JOSEPH M. FARLEY NUCLEAR PLANT, UNIT NO. 1

Amendment No. 58  
License No. NPF-2

SAFETY EVALUATION BY THE OFFICE OF NUCLEAR REACTOR REGULATION  
RELATED TO AMENDMENT NO. 58 TO FACILITY OPERATING LICENSE NO. NPF-2

Figure 3.4-2 Farley Unit 1 Reactor Coolant System Heatup Limitations Applicable For The First 7 EPY

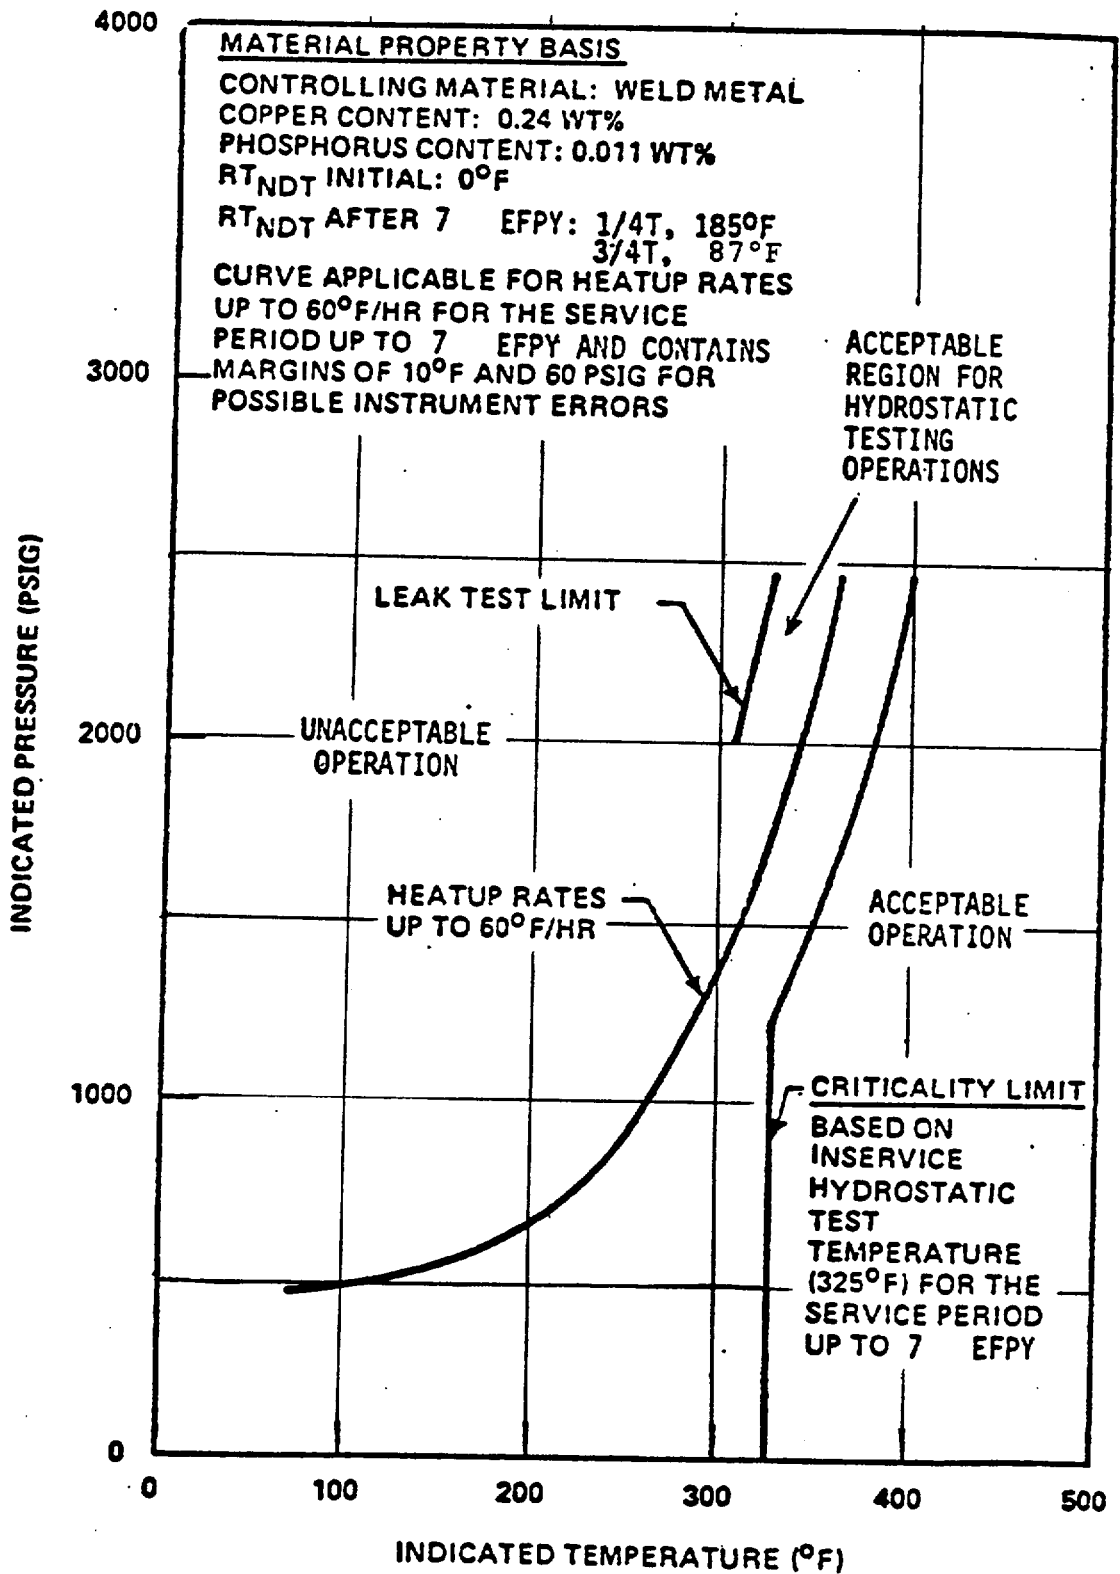
The amendment modifies Technical Specifications (Table 4.4-5 and Figures 3.4-2 and 3.4-3) relating to the reactor vessel material surveillance schedule and heatup and cooldown curves extending the curves to seven effective full power years of operation. These changes are based on WCAP-10474 provided by licensee letter dated March 1, 1984 and are in accordance with 10 CFR 50, Appendix H, published May 31, 1983.

flange region of 0°F and 60°F, respectively, we have determined that the proposed pressure-temperature limits are acceptable for 7 effective full power years.
